Village of Bayside
9075 N. Regent Rd.
Architectural Review Committee Meeting
May 21, 2018
Village Hall Board Room, 6:00 pm

**ARCHITECTURAL REVIEW COMMITTEE
AGENDA**

VILLAGE CODE REVIEW

PLAT OF SURVEY

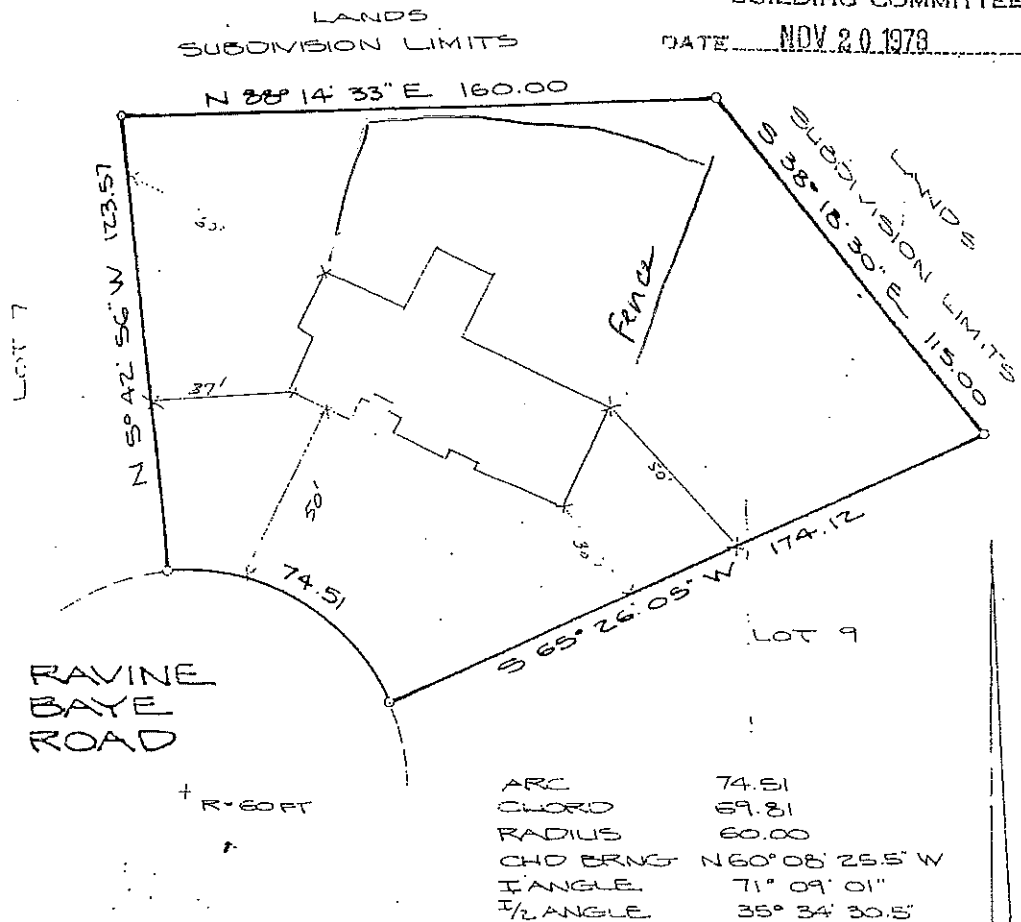
New fence. 150ft long, 4' tall in side and rear yards.

Proposed length of 150' is approximately 23% of the total property perimeter length of approximately 647'.

Per the code section copied below a 25% open fence is required.

Option 1: 4" wood pickets w/ 2" gaps = 33% open

Option 2: black metal verticals w/ 3" gaps = more than 50% open

BOTH PROPOSED FENCE LENGTHS / TYPES COMPLY

Black metal requires ARC approval.

Prepared For Cream City Construction

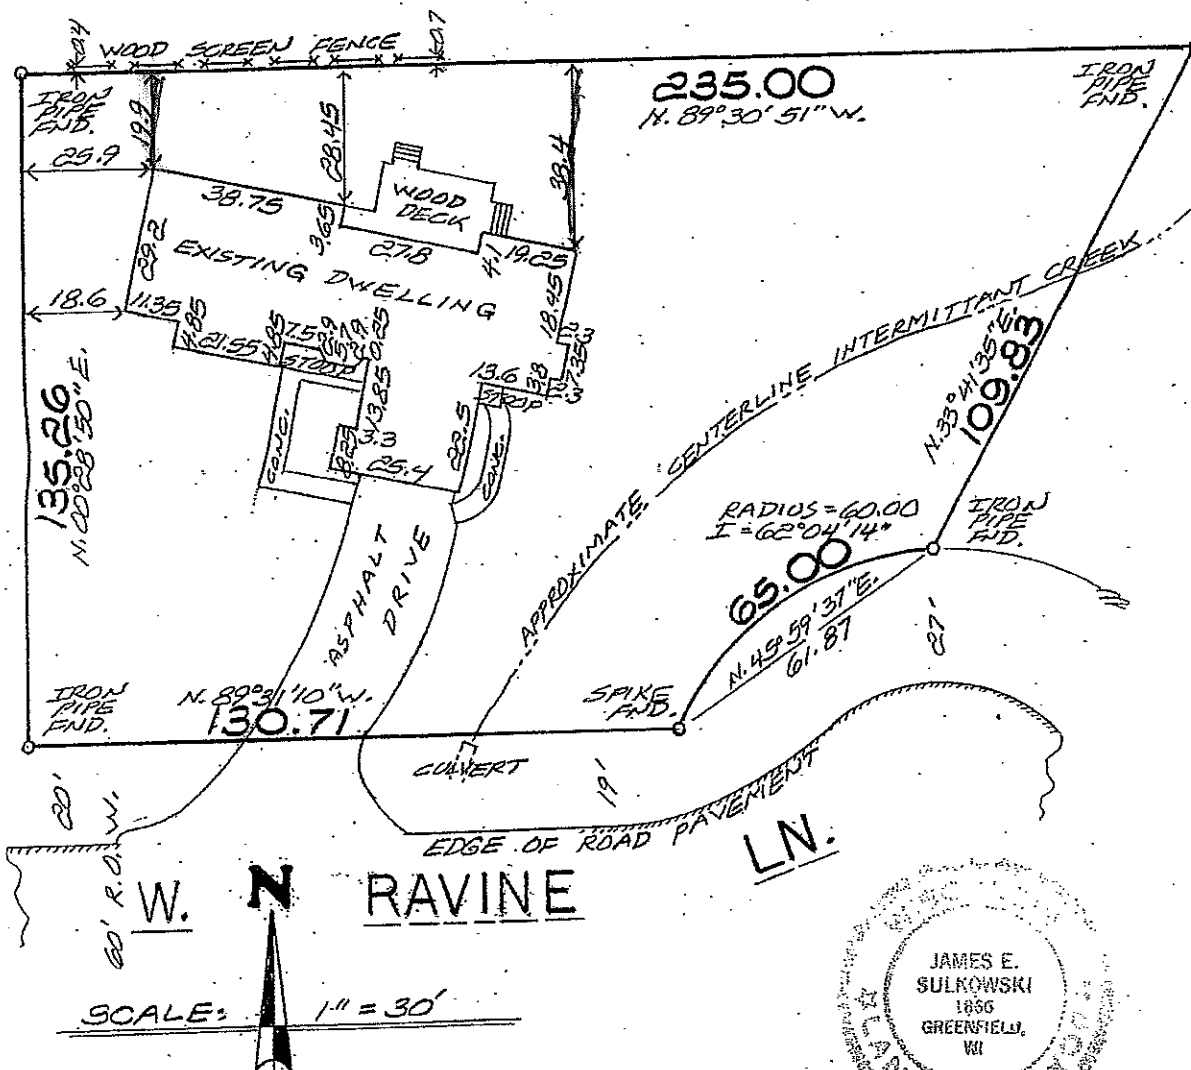
New fence. 49' long, 4' tall in side and rear yards.

Proposed length of 49' is approximately 7% of the total property perimeter length of approximately 675' and a solid fence is permissible.

PROPOSED FENCE LENGTH & TYPE COMPLY

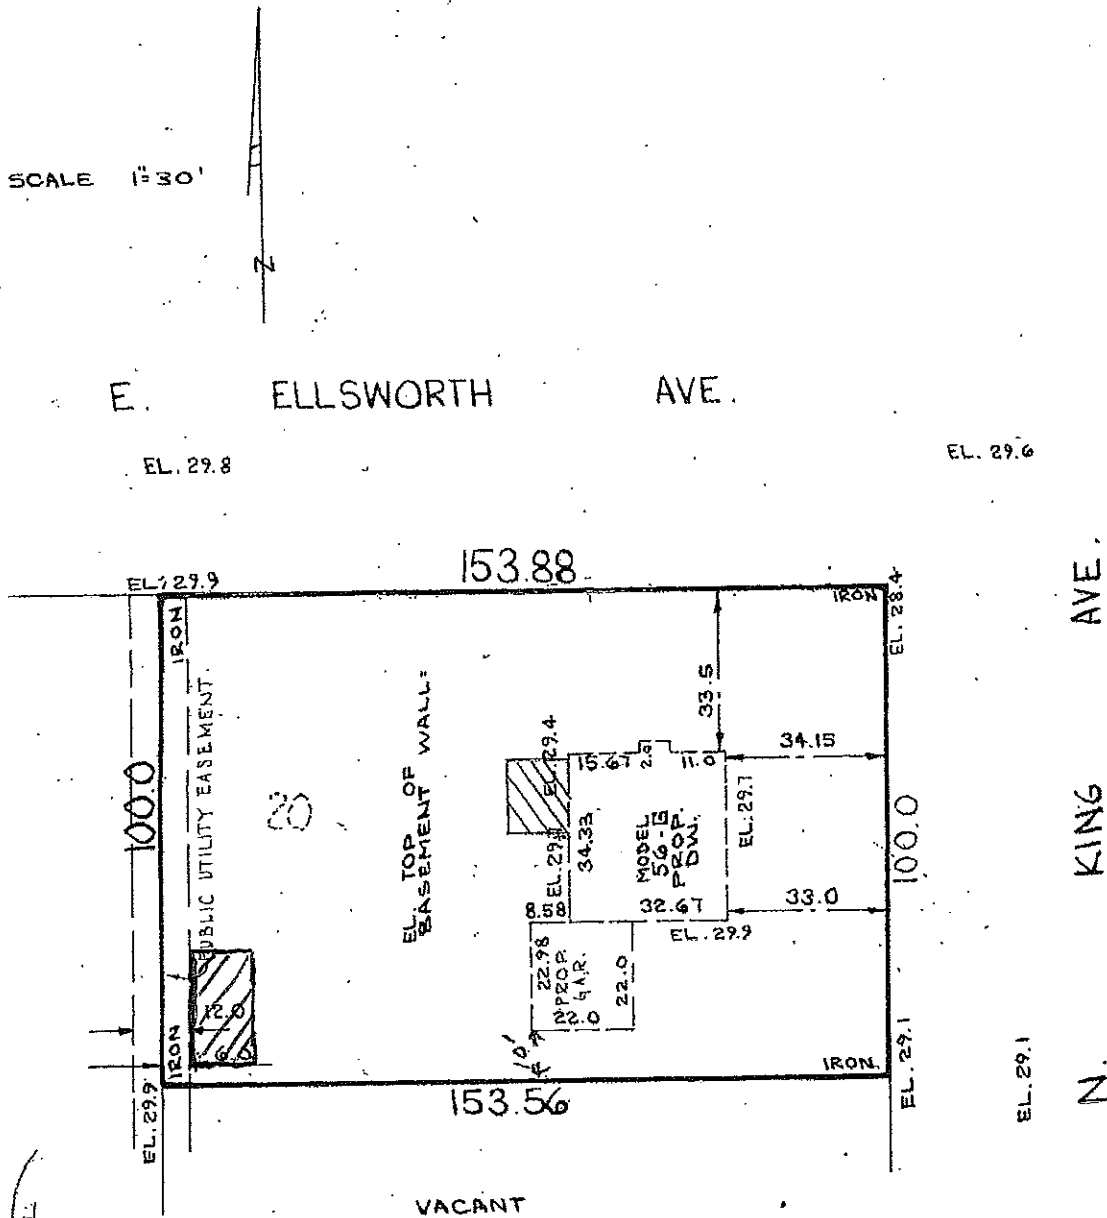
The owner plans to build an accessory structure storage shed in their back yard. The accessory structure must be located within all building setbacks, including a 10' side yard setback and 10' rear yard setback per Village Code section 125-91 "C" residence district regulations and section 104-4(f) Accessory structures.

Plot plan shows accessory structure near the property lines and does not comply with the setback requirement noted above.
